Seventy-fourth session

Regulation No. 100 (Electric power trained vehicles)

Proposal for the 04 series of amendments to Regulation No. 100 (Electric power trained vehicles) *

Submitted by the expert from the Russian Federation

Figure 8
Placement on a vehicle of category N₃

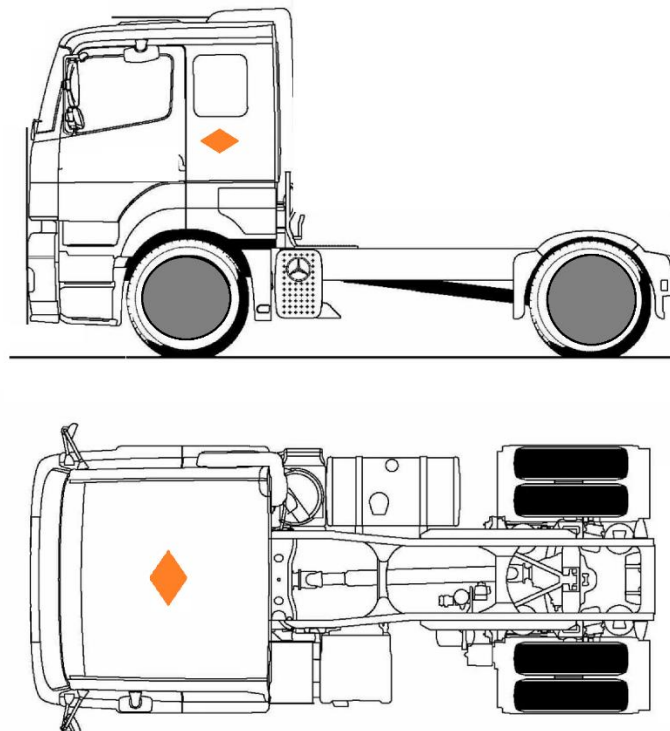
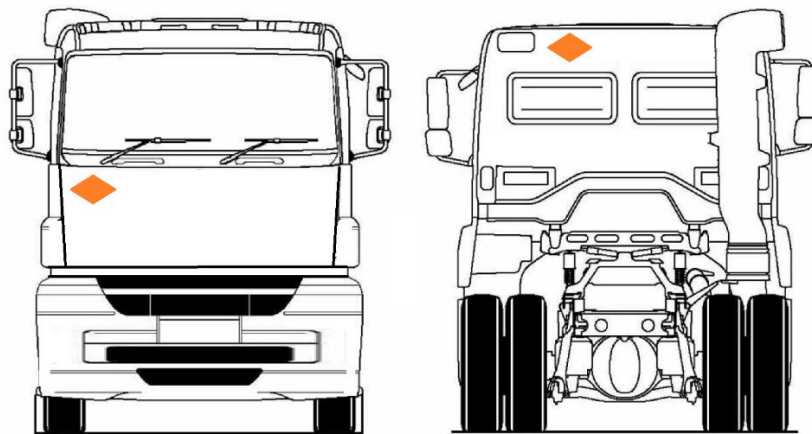
The identification sticker on the N₃ category vehicles shall be placed on four sides and optionally on the roof (Figure 8):

- (k) at the front: from the passenger side on the windscreen or the body (the sticker shall contrast with the background);
- (l) on the right and on the left: on the outside of the doors
- (m) at the rear: upper corner of the rear window from the driver side. In case of absence of the rear window, on the rear part of the body from the driver side;
- (n) at the top next to the emergency exit.
